NORTHERN BEACHES LOCAL PLANNING PANEL

WEDNESDAY 16 JUNE 2021

ITEM 3.1	DA2020/1597 - 67 PACIFIC PARADE, DEE WHY - DEMOLITION WORKS AND CONSTRUCTION OF A BOARDING HOUSE DEVELOPMENT
AUTHORISING MANAGER	Lashta Haidari
TRIM FILE REF	2021/410227
ATTACHMENTS	1 Assessment Report 2 Site Plan & Elevations 3 Design & Sustainability Advisory Panel Report

Section BB showing the side envelope breach (source Benson McCormack)

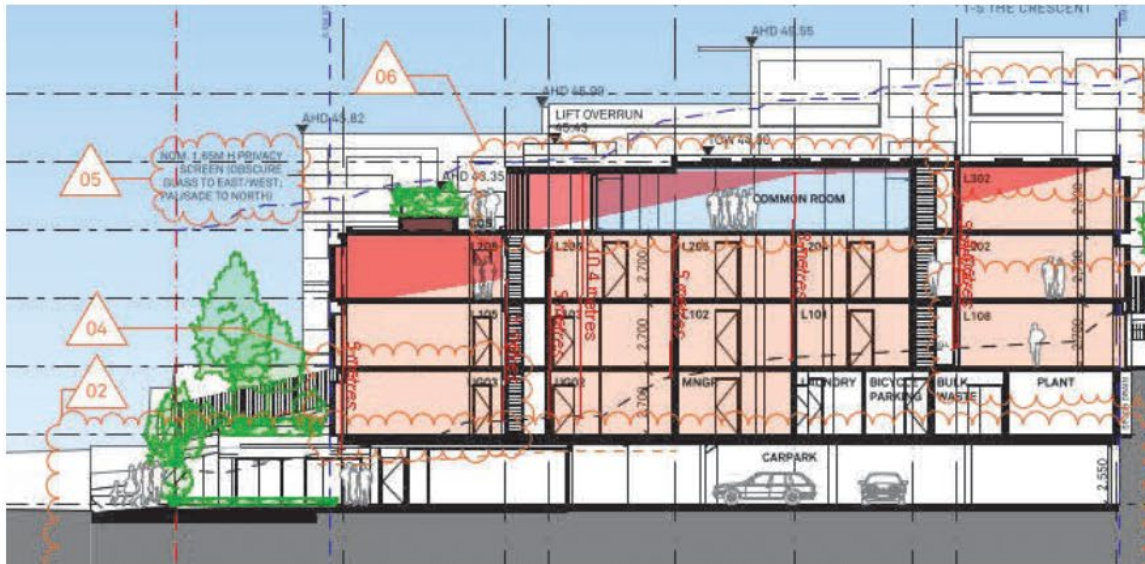
Area 1 - (3m - 2.4m in height x 7.6m in length) which relates to unit L208 and the roof top planter.

Area 2 - (2.9m - 0m in height x 12m in length) which relates to the roof top common room.

Area 3 - (1.9m - 0m in height x 5.7m in length) which relates to unit L302

Section AA showing the side envelope breach (source Benson McCormack)

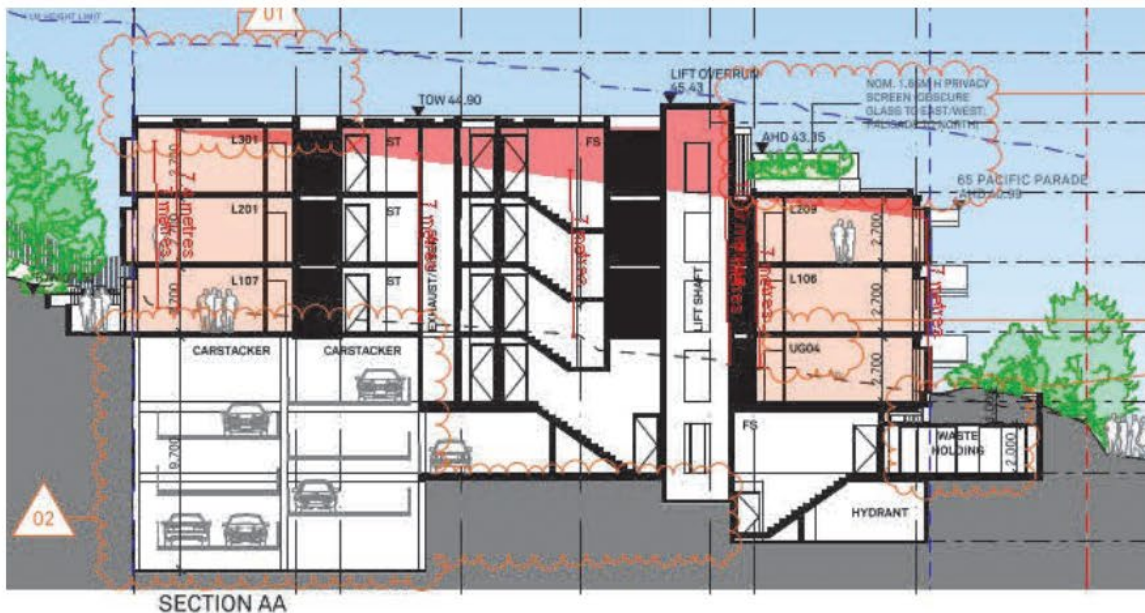
There are two (2) areas of envelope breach as detailed below:

Area 1 - (3.9m - 0m in height x 23m in length) which relates to the lift shaft, the top of the central service core and the top of unit L301

Area 2 - (1m - 0m in height - 6m in length) which relates to the top of unit L209

3D image of 45 degree plane showing envelope breach (source B McCormack)

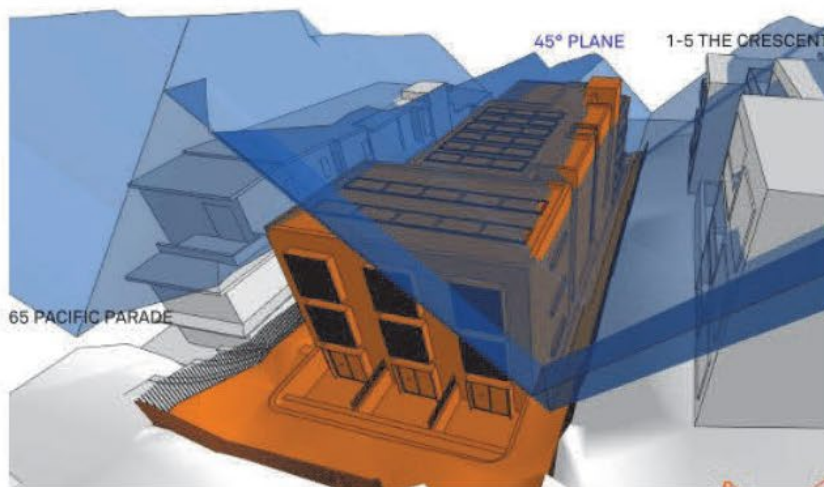
3D image of 45 degree plane showing envelope breach (source B McCormack)

Figure 2: Extract of CDC2019/0461 approved Section 1 drawing no. CDC30000

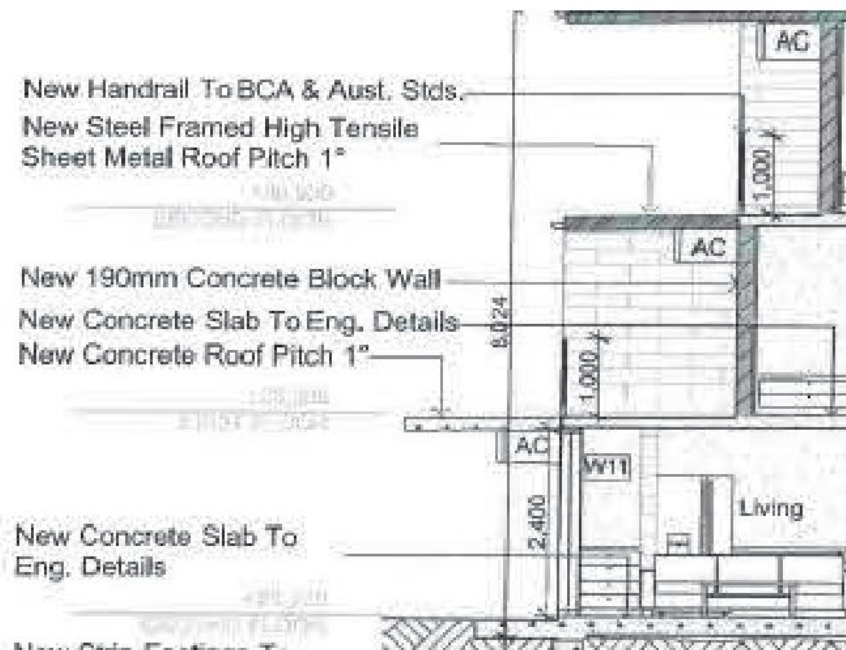
CDC2019/0461 floor plan and sections indicate the concrete slab shown in Figure 1 as being a new steel framed high tensile sheet metal roof with a pitch of 1 degree (Figure 2 and 3).

Figure 4: Approved CDC2019/0461 Engineering Plan No. S04 - Second Floor Plan with Applicant mark up

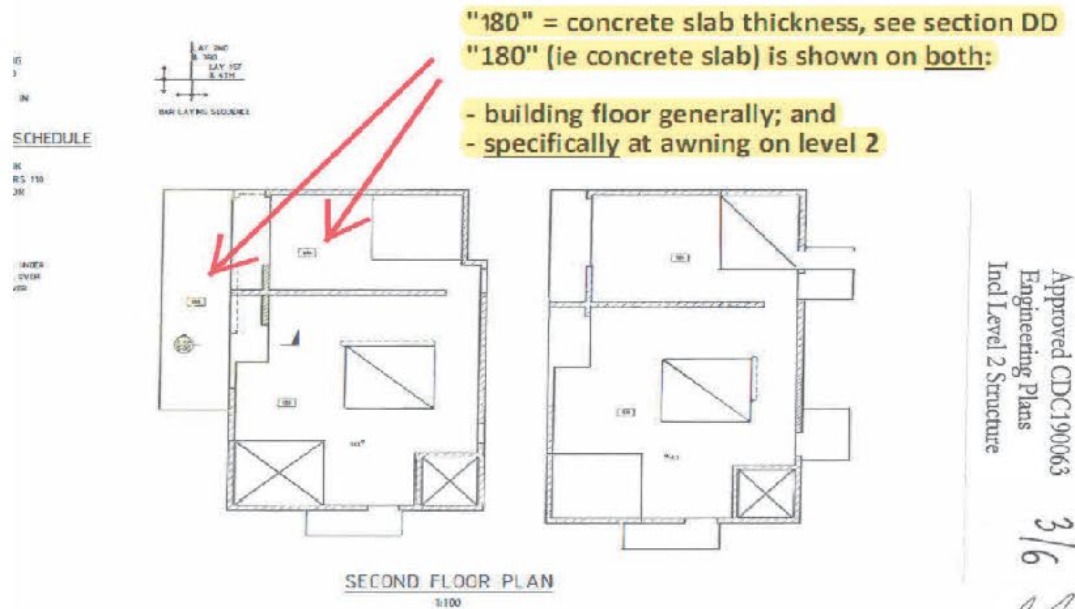
The applicant as part of the review of determination application submitted annotated engineering plans approved as per Schedule 1 of CDC2019/0461 (Figure 4 and 5) to indicate the concrete slabs have been approved as part of the CDC.

The engineering plans approved in CDC2019/0461 indicate the subject unauthorised structure as a 180mm concrete slab.

Figure 5: Approved CDC2019/0461 Engineering Plan No. S06 Section DD with Applicant mark up

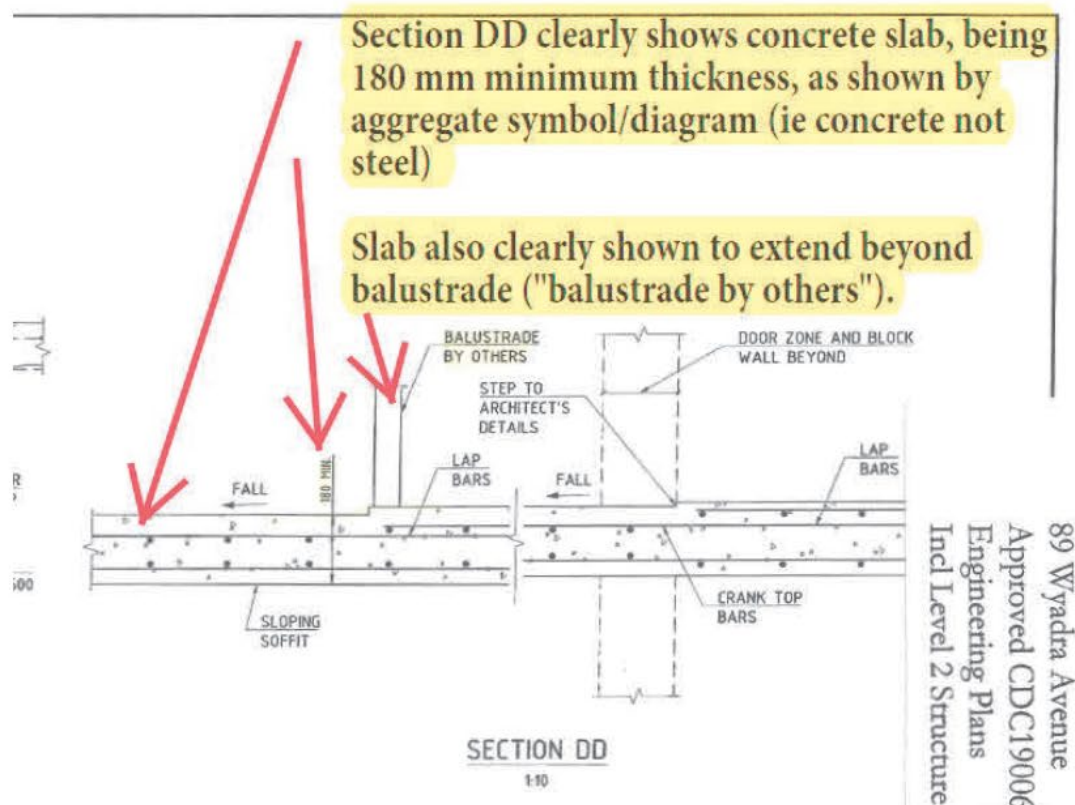
Although there are some inconsistencies between the Architectural Plans and the Engineering Plans, both were submitted and approved as part of CDC2019/0461 by the Private Accredited Certifier dated 21 June 2019. It is noted only the subject Architectural Plans endorsed by CDC2019/0461 for the construction of the group home are stamped.
